<b>COA # 2010-COA-174 (WD)</b>	<b>INDIANAPOLIS HISTORIC PRESERVATION COMMISSION STAFF REPORT</b>	Hearing Date <b>JUNE 2, 2010</b>
<b>105 S. Meridian St. Wholesale District</b>		NEW CASE
<b>Applicant</b>	<b>RATIO ARCHITECTS FOR 105 S. MERIDIAN, INC.</b>	
mailing address:	107 S. Pennsylvania, Suite 100 Indianapolis, IN 46204	
<b>Owner:</b>	<b>105 South Meridian, Inc.</b>	
	105 S. Meridian Indianapolis, IN 46225	
<b>CASE</b>		
<b>IHPC COA:</b>	<b>2010-COA-174 (WD)</b>	• Replace the steel windows on floors 2 through 9 of the north and west elevations with new aluminum windows
<b>STAFF RECOMMENDATION: Approval</b>

**To approve a Certificate of Appropriateness for replacement of existing steel windows on floors 2 through 9 at the north and west elevations with new aluminum windows, all per submitted documentation and subject to the following stipulations:**

PROJ. NO.: 09046.000 SHEET NO. W-1

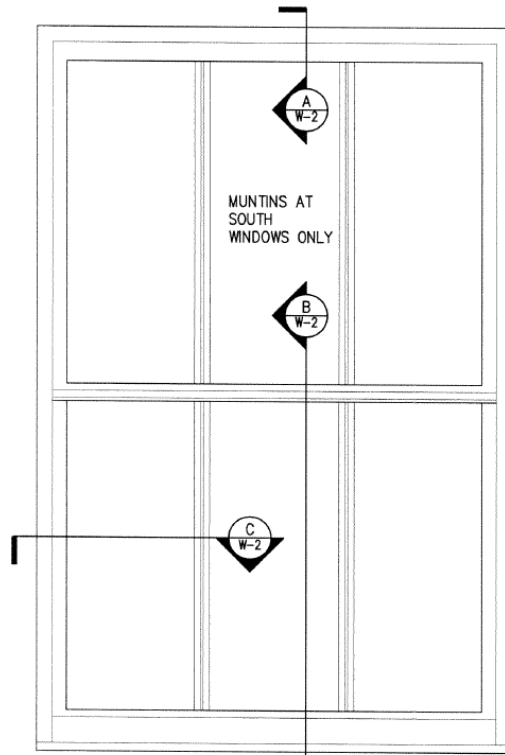
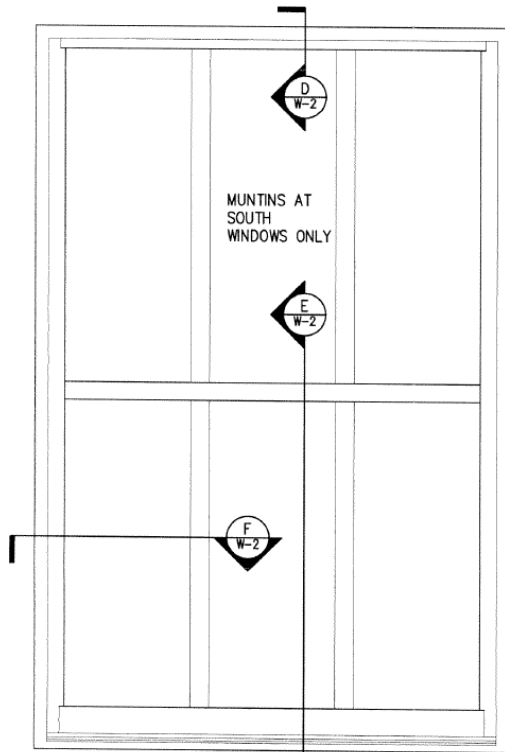
The applicant proposes the 219 units on the north and west elevations between floors 2 and 9 be replaced with a Graham Series 1200 fixed aluminum window. The replacements will fit the existing openings and mimic the existing 1/1 configuration. There are minor alterations to the profile, specifically in the head, sill and jamb (see attached section details).

1. It is likely the existing windows are replacements windows.
2. The commission has previously approved replacement windows on this building in 1996.
3. The proposed replacement windows have the same configuration to the original and existing windows with minimal changes in dimension/profile and will not create an adverse effect architecturally.
4. From the standpoint of visual aesthetics, the difference between steel and aluminum is limited, if comprehensible at all.
5. The cost between repair and aluminum replacement windows is minimal; with the replacement actually being the more economic option and offering reduced ongoing maintenance.

1. New windows must fit the existing openings; altering existing openings is NOT permitted.
2. No changes to the proposed window specification, design, locations, configuration, or method of installation are permitted without prior consultation with IHPC staff.
3. Glass shall be clear; any addition of beveling, frosting, etching, caming, or stained glass is NOT permitted under this approval.
4. Any deviation from this approach shall be approved by the IHPC prior to installation.
